Illinois Power Company  
Clinton Power Station  
P. O. Box 678  
Clinton, IL 61727  
Tel 217 935-5623  
Fax 217 935-4632

November 3, 1995

Subject: Illinois Power's (IP's) Response to the NRC's  
Requests for Information Regarding Thermo-Lag

Fire Scenario Originating in 0AP87E,  
Cross-Section of Fire Zone CB-1e

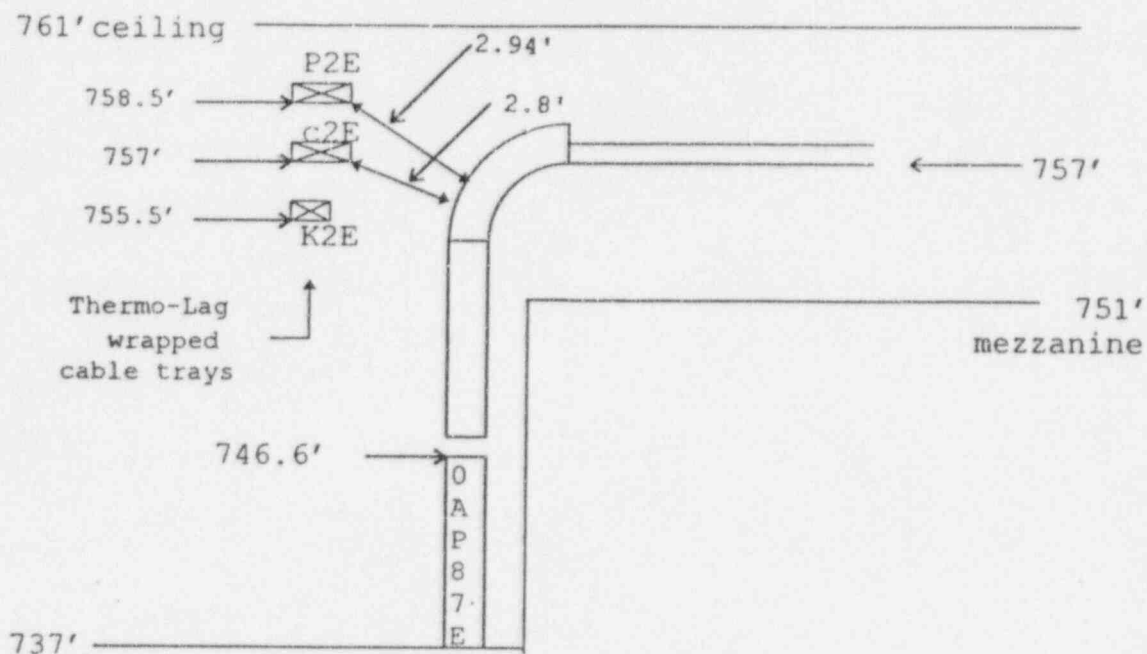
Conclusions stated by the licensee in the detailed justification for the deviation in this area are not technically supported. For example, the licensee stated that cable trays are all located high in this fire zone, therefore it is not credible to postulate cable damage from a fire at the floor level. This conclusion is not correct. It appears that the analysis only considers flame impingement as a credible initiator of cable damage, the licensee has not considered the rapid rise in temperature in the plume generated by a floor level fire, the high temperatures expected in the descending hot gas layer and the radiant energy transfer from these sources to the target cables, as sufficient to damage the cables. No basis has been provided to exclude these sources as potential initiators of cable damage. Provide the technical basis for excluding these sources for cable damage.

The licensee also concluded that a hot gas layer cannot be formed due to the use of conduit for cables not in trays, large distances between ignition sources and targets, and the use of IEEE-383 qualified cable. These considerations have little if any effect on the potential for the formation of a hot gas layer. The factors that affect the formation of the hot gas layer are the heat release rate of the fuel, fuel surface area, the compartment geometry and the compartment ventilation. Provide an analysis that considers all relevant factors in the formation of a hot gas layer.

The impact of a fire in 0AP87E was first examined by determining the location of 0AP87E in relation to the Thermo-Lag wrapped cables. No wrapped cables are located directly over the panel. Therefore, no impact from direct flame impingement or from the fire plume, other than heat up of the HGL, was possible. Figure 1 displays the potential fire scenario involving 0AP87E.

In this scenario, the highest wrapped tray is initially partially within the ceiling jet sublayer. As the surface of the fire continues vertically, the tray quickly (within the first 1.08 feet of cable) fails to meet the 15% criteria for being affected by the ceiling jet sublayer. This movement of the fire surface is the major source of uncertainty in analyzing this scenario.

For those portions of the highest wrapped tray that are below the ceiling jet, no potential for damage to the tray from the jet exists. In this regard, the temperature of the ceiling jet at the highest point on the riser where the 15% criteria is met is only 193.9°F, well below any temperature where damage to electrical cables or Thermo-Lag could occur.

Fire Scenario Involving CC Pump  
Cross-Section of Fire Zone CB-1f

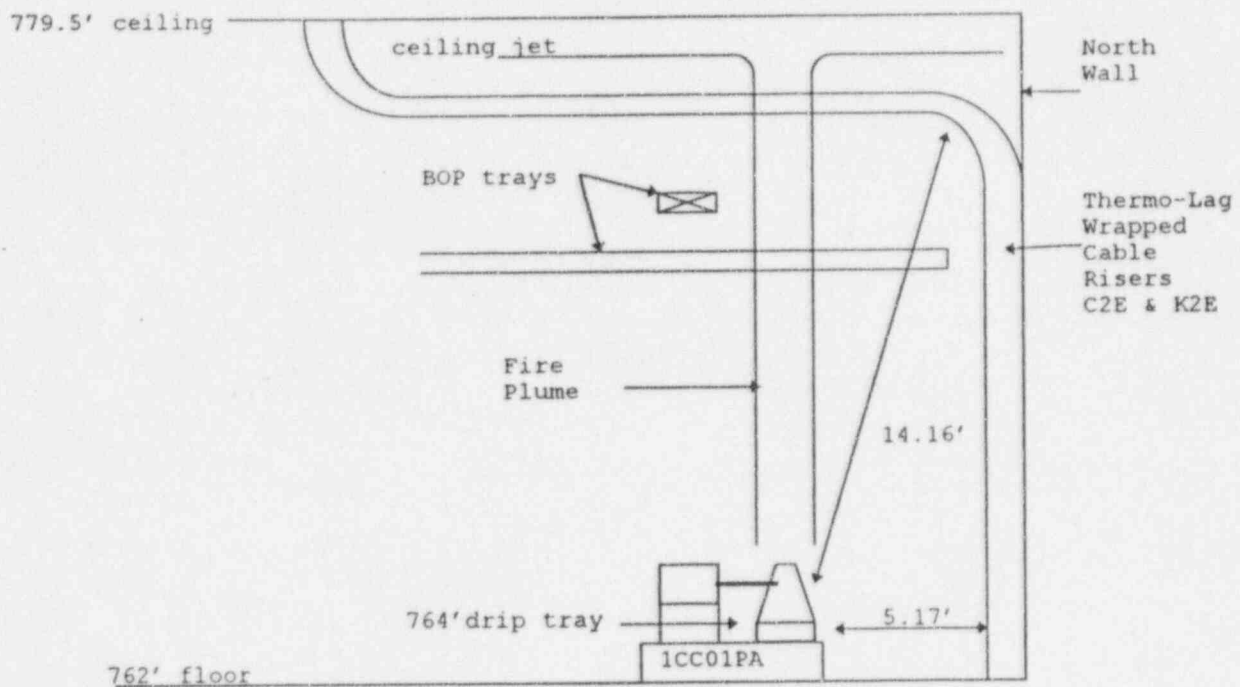
In this fire zone the licensee concluded that based on fire modeling there is no credible risk to safe shutdown equipment from either fixed or transient combustibles. The staff believes that the uncertainties associated with the use of fire modeling, due to the lack of experimental validation of the models for typical nuclear power plant compartments, and the lack of adequate data on the fire performance of components susceptible to fire damage typically present in a plant, make it unreasonable to conclude, based solely on the results of a fire model, that there is no credible risk of damage to redundant safe shutdown components from fixed and transient combustibles. Provide the detailed validation and verification of the fire model used in this analysis.

The licensee has concluded that based on the NEI Application Guide for Thermo-Lag Fire Barrier Systems that the Thermo-Lag installed in this area has a fire endurance of 85 minutes. Provide the detailed analysis that the Thermo-Lag barriers installed in this are qualified to an equivalent fire rating of 85 minutes including hose stream testing.

The CC pumps each have a drip tray located beneath the pump section of the pump-motor installation. These trays are rectangular with dimensions of 2.15 feet by 3.29 feet. Based on these dimensions a HRR of 954 BTU/s was calculated for oil fires originating from the CC pumps.

The wrapped horizontal trays make two 90° lateral bends and only pass over one of the CC pumps (1CC01PA) and are a minimum of 12.25 feet above the drip tray. While there are some intervening unwrapped cable trays, the location of these trays and their construction precludes cable ignition from occurring. With a Thermo-Lag ignition temperature of 1000°F and a HRR of 954 BTU/s, the wrapped trays would have to be within 8.7 feet of the surface of the fire for ignition to occur. This separation is also sufficient to prevent damage to the cables even without taking credit for the Thermo-Lag. Correspondingly, no potential impact from plume effects, other than heat up of the HGL, resulting from a CC pump oil fire exists.

The Thermo-Lag installation nearest the CC pumps is a vertical installation surrounding two cable risers and the overhead wrapped horizontal cable trays discussed above. The nearest CC pump drip tray (1CC01PA) is offset 5.17 feet from the vertical Thermo-Lag installation. Due to the proximity of this installation to 1CC01PA, the potential for ceiling jet or radiant energy exposure was examined. Figure 2 displays the fire scenario involving CC pump 1CC01PA and the vertical Thermo-Lag installation.

**#8 AWG, 1/C ampacity as a percentage of the IEIN 94-22 test result value for open tray**

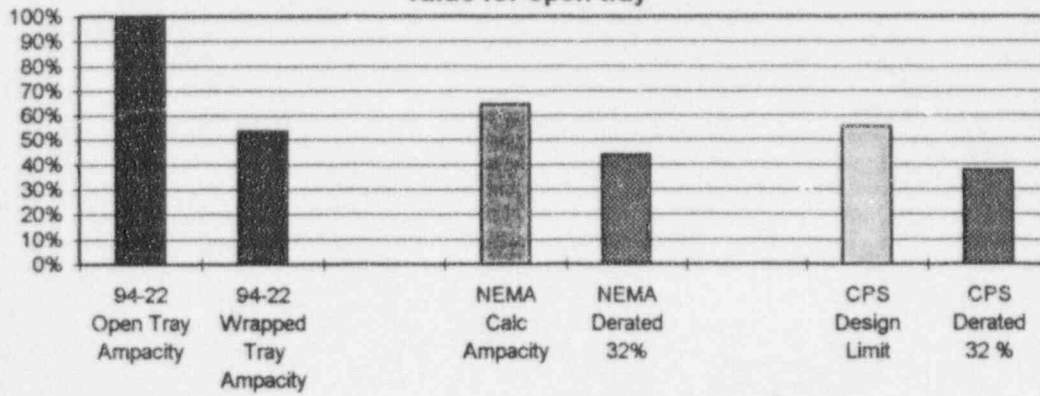
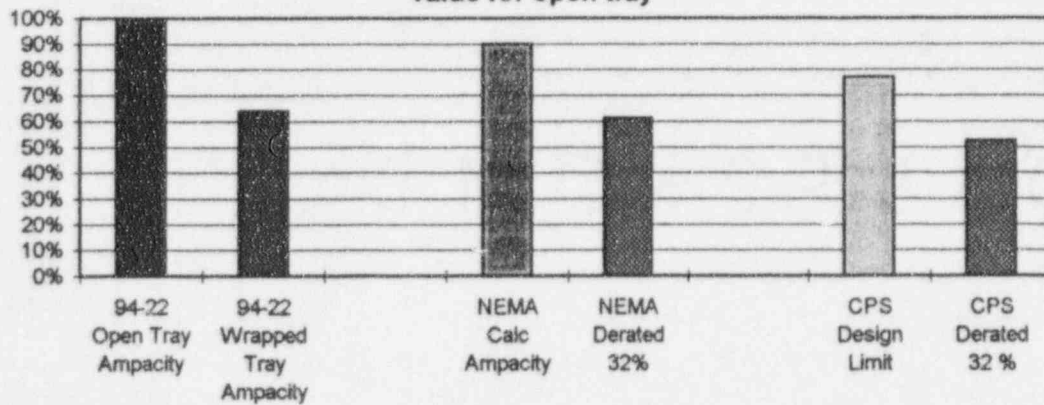
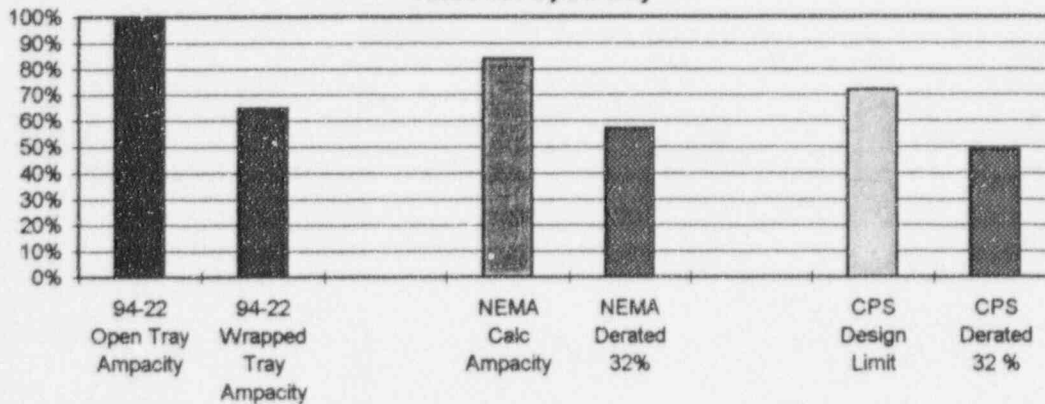
Given that there are no unresolved technical issues, the licensee is requested to provide its site-specific schedule and plans for the resolution of the ampacity derating issue for Thermo-Lag fire barriers.

If a Nuclear Energy Institute (NEI) test program or analysis is expected to be utilized by the licensee, please provide specific program details and incorporate any input by NEI into the licensee's overall schedule.

As demonstrated by these charts, the derating factor at CPS (32%) is numerically smaller than the test value reported by the NRC in IEIN 94-22 (35%, 36%, and 46%). However, the charts also show that the actual ampacity values that would be allowed at CPS, both before and after derating, are significantly lower than the NRC values for the same cables. CPS's cables have substantial margin due to the utilization of a more conservative methodology.
